WORK INSPECTION REQUEST (WIR) FORM

Contractor:	HAIF-FREYSSINET JV
Project:	RA2RC
Contract No.:	QPMO-410-CT-00618
Work Inspection Request Number:	QRXM114000-HFC-TEC-WIR-ITS-02-RO5-00001

Inspection request for Installation of Road Weather Information System (RWIS)-1no, Air Quality Monitoring (AQM)-1no and 7mtr ITS Pole-1no. Mainline 02- Spliting At Station.2+800.

Project Name: Package 3 - Interim Road Access to Resort Core	**Project Code:** QRXM114000
**Location: RA2RC ** Qiddiya INTERM ROAD	**Date:** 14-February-2026
Document Title: Method of Statement for Installation and Commissioning of Intelligent Transportation System Equipment and Devices.	**Ref No: QRXM114000-HFC-TEC-MST-ITS-02-RO5-00001**
	Rev No: 00

Drawing title: ITS SHOP DRAWINGS
ITS LAYOUT PLAN

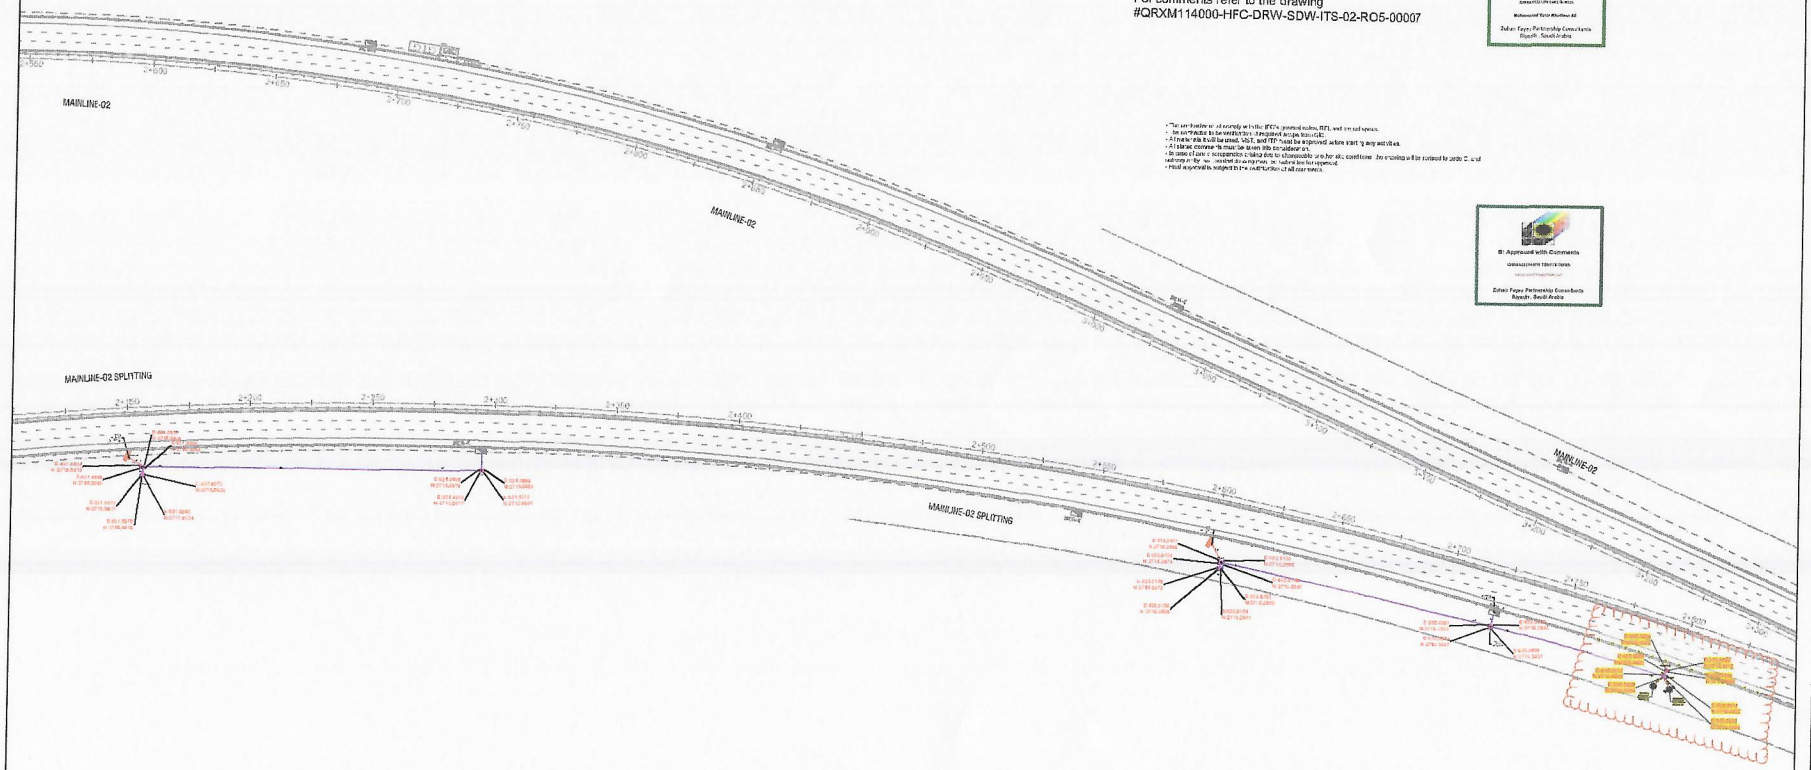
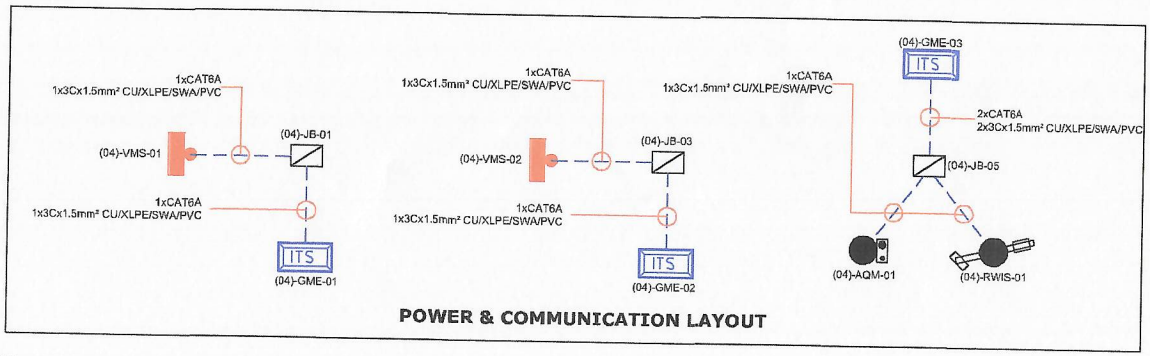
For comments refer to the drawing
#QRXM114000-HFC-DRW-SDW-ITS-02-RO5-00007

ROAD WEATHER AND INFORMATION SYSTEM (RWIS) AND AIR QUALITY MONITORING (AQM) ON 7m ITS POLE TYPICAL DETAILS

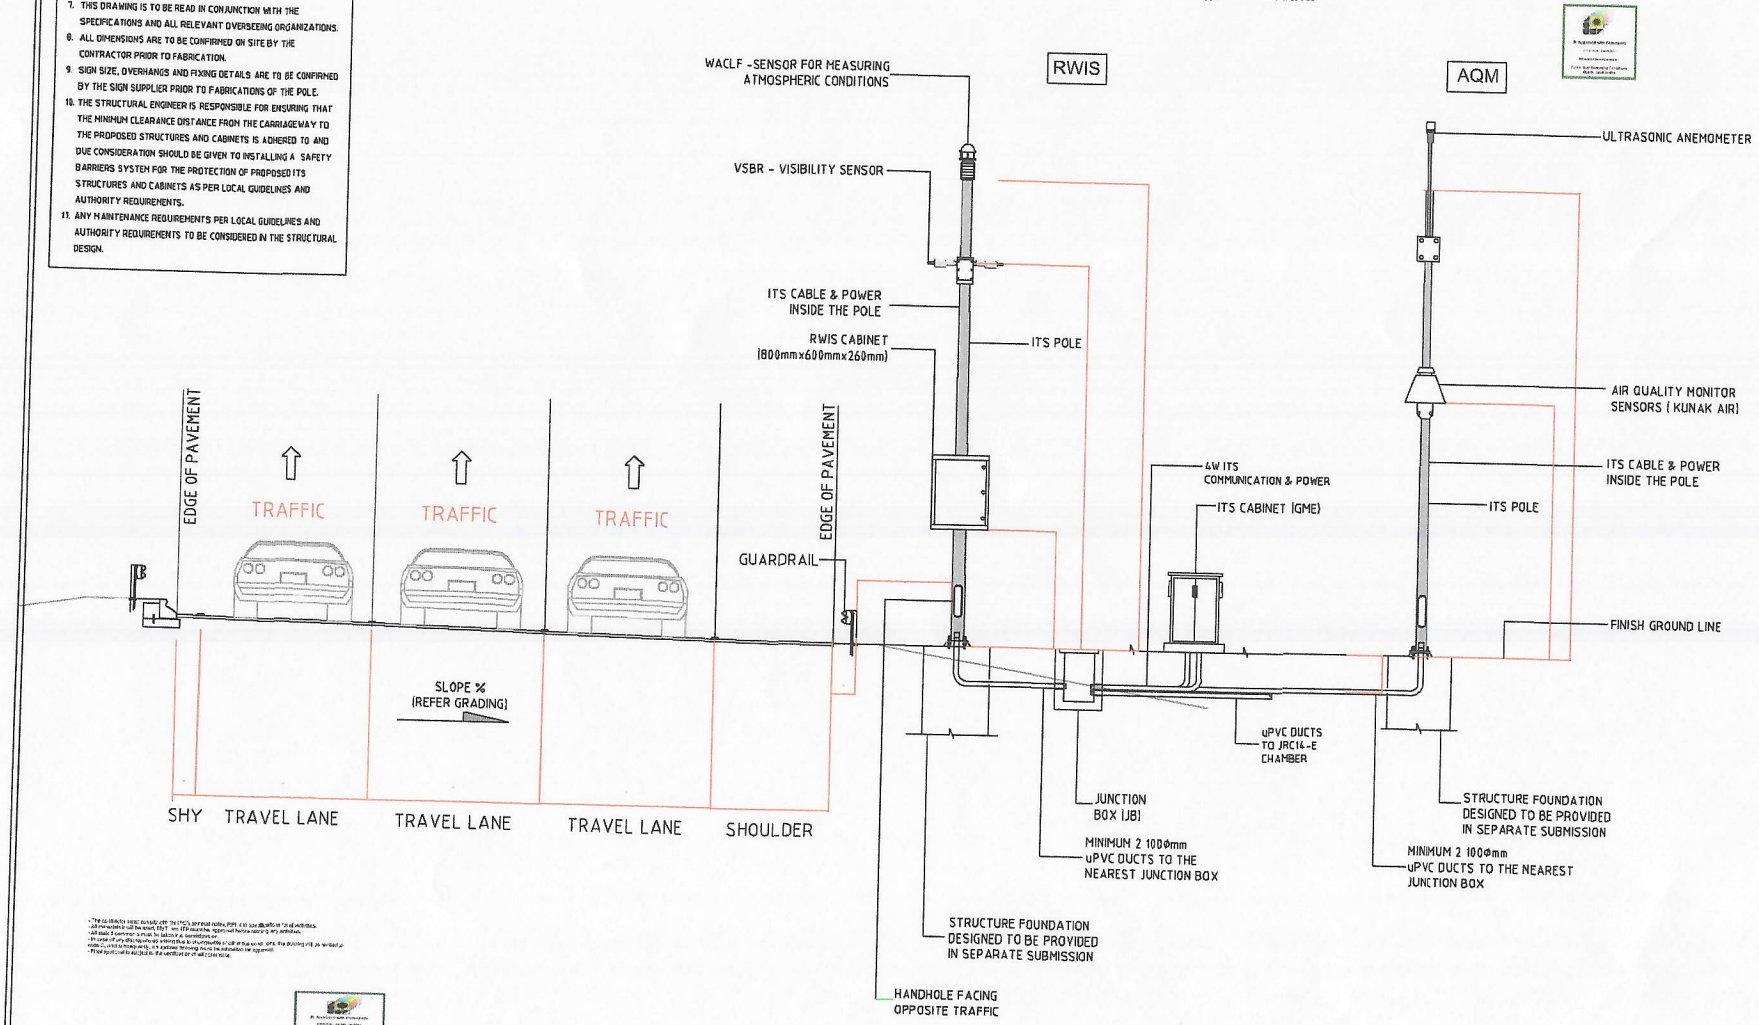
1.Mounting heights of devices shall be as per site conditions and manufacturer recommendation to achieve optimal performance
2.All the work shall be carried out in compliance to project specification and applicable standard & codes
